AMENDMENT NO. 1 DECEMBER 1980
TO
IS : 8395 (Part I) - 1977 SPECIFICATION FOR
CABLE TERMINATIONS FOR AUTOMOBILE WIRING
PART I BLADE TYPE CONNECTORS (MALE AND FEMALE)

Alteration

TABLE 1 MALE BLADE CONNECTOR

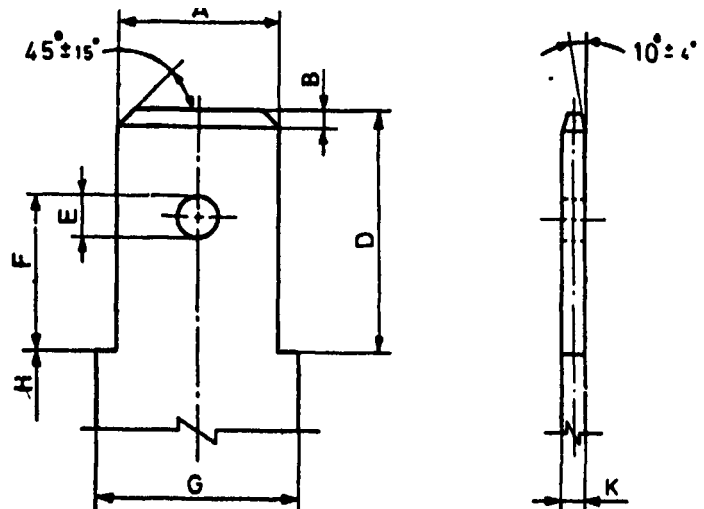
(Page 5, Table 1) — Substitute the following for the existing table:

WIDTH OF MALE TAB	A	B	D	E (DIA)	F	G	H	K
	+ 0 - 0.1	± 0.3	± 0.1	± 0.1	+ 0 - 0.2	Min	Min	± 0.02
2.8	2.9	1.0	7.0	1.2	3.5	4.0	1.5	0.5
4.8	4.8	1.0	7.0	1.40	4.0	6.0	2.5	0.5
6.3	6.4	1.0	8.0	2.3	5.0	8.0	2.6	0.8
8	8.1	1.0	12.5	2.3	8.0	10.0	2.6	1.0
9.5	9.6	1.0	14.0	2.3	9.0	12.0	2.6	1.1
